Subject: Hardened Intersite Cable System Pressurization Simulation,
Wing I,

Reference: CCN 421

Work Done in Support of CCN 421

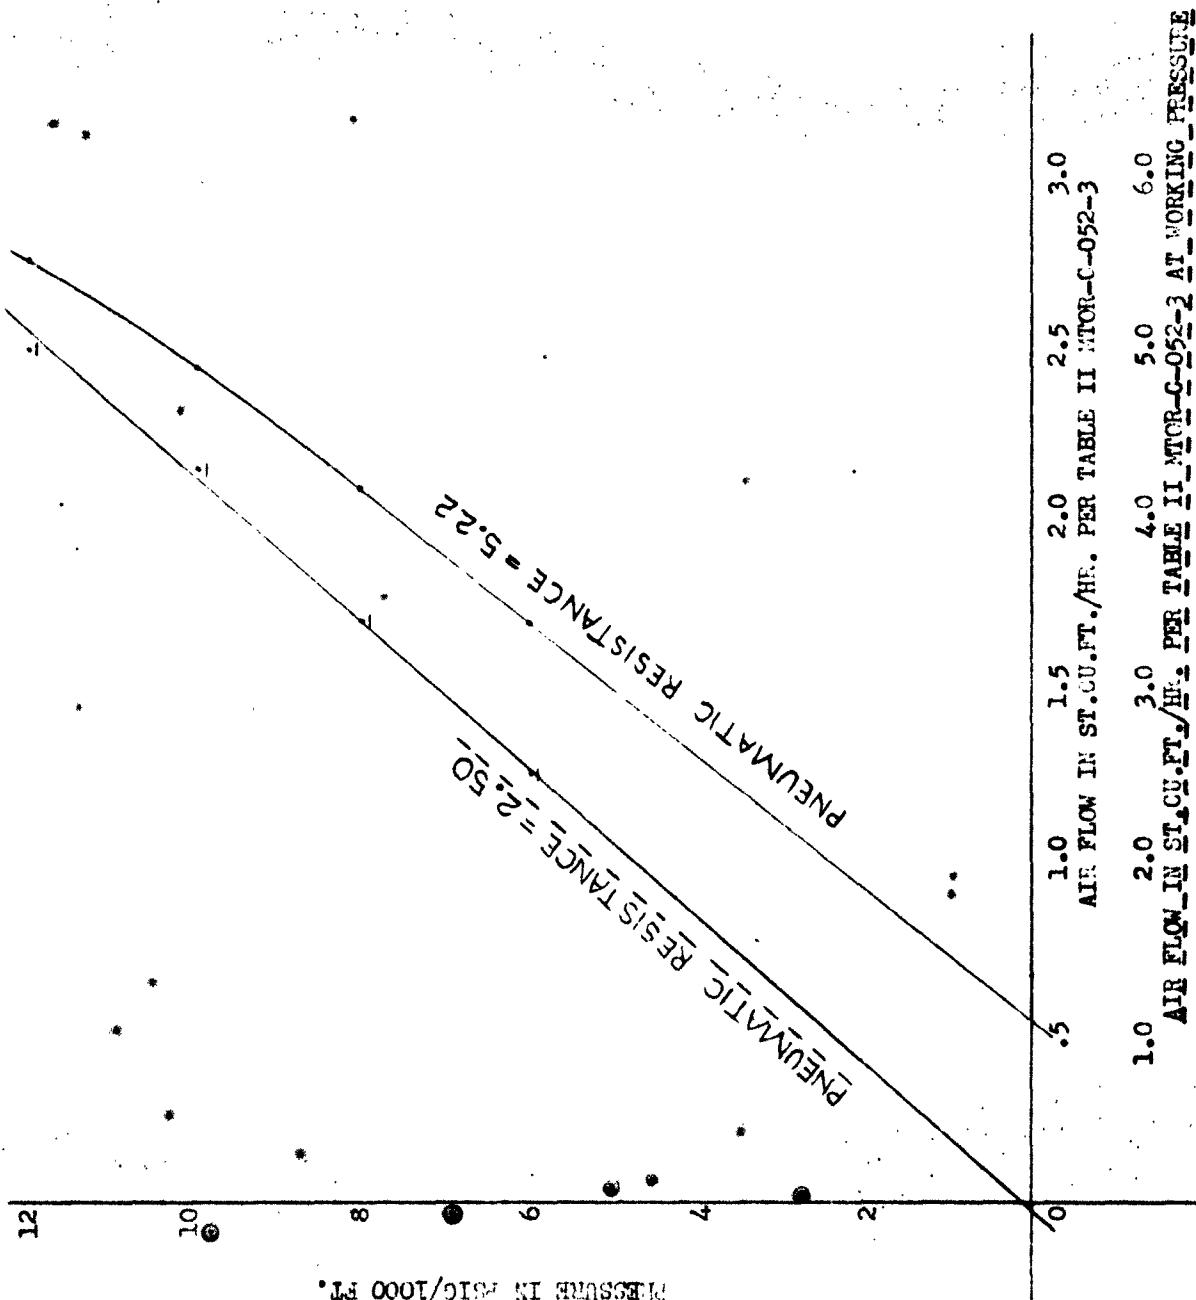
Another indication that the air flow rates in MTOR-C-052-3 are LPG meter readings is that the graph of pressure versus air flow does not pass through the origin of the graph, but the graph of the readings used as air at the working pressure converted to standard conditions does pass through the origin, see Figures A, B and C.

FIGURE B
PNEUMATIC RESISTANCE
CABLE - 50 PAIR 19 AWG

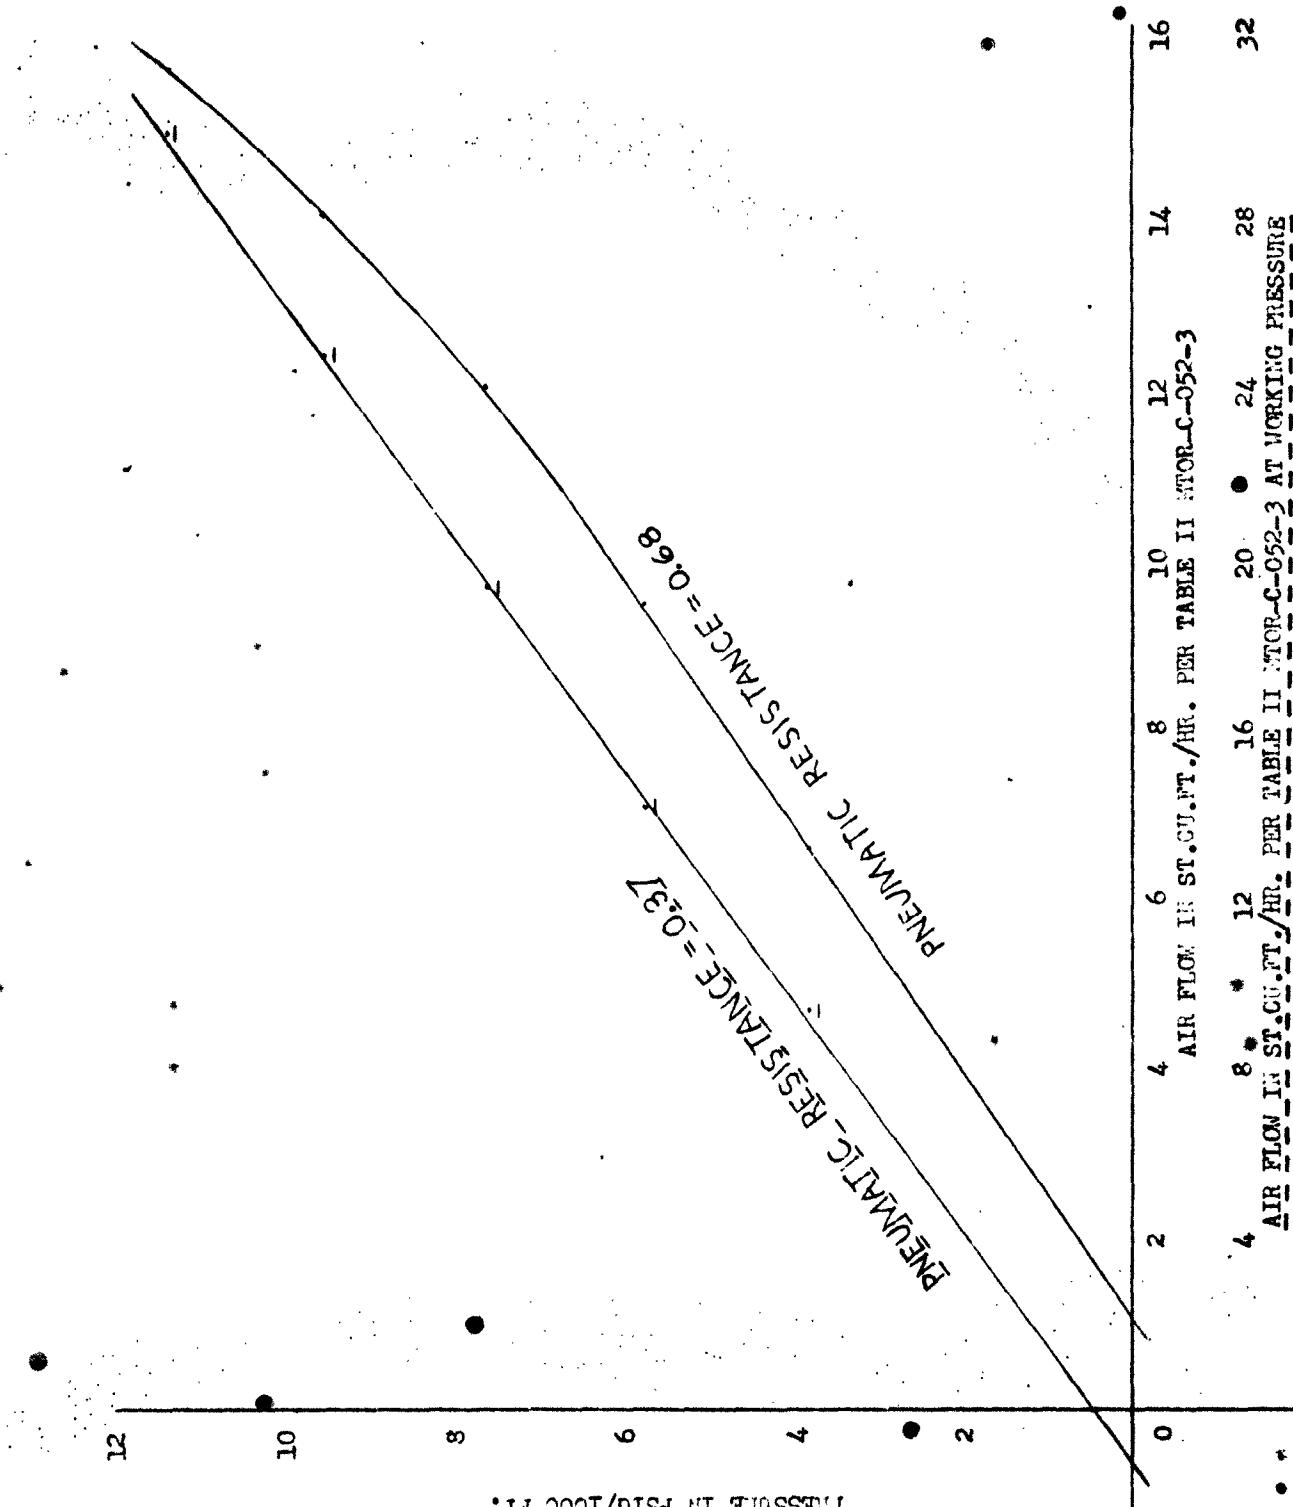
It appears from the pictures of the equipment that the volume recording meter is a LPG meter, low pressure gas meter, instead of a meter recording air flow at the working pressure in units of standard cubic feet as implied.
